June 15, 2010

Vogtle Electric Generating Plant
License Amendment Request for Adoption of TSTF-425-A, Rev. 3,
Risk-Informed Justification for the Relocation of Specific Surveillance Frequency
Requirements to a Licensee Controlled Program
Using the Consolidated Line Item Improvement Process

**Vogtle Electric Generating Plant
License Amendment Request for Adoption of TSTF-425-A, Rev. 3,
Risk-Informed Justification for the Relocation of Specific Surveillance
Frequency Requirements to a Licensee Controlled Program
Using the Consolidated Line Item Improvement Process**

SURVEILLANCE	FREQUENCY
SR 3.4.7.3 Verify correct breaker alignment and indicated power are available to the required RHR pump that is not in operation.	7 days

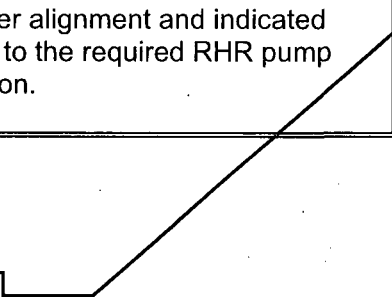
In accordance with the Surveillance Frequency Control Program
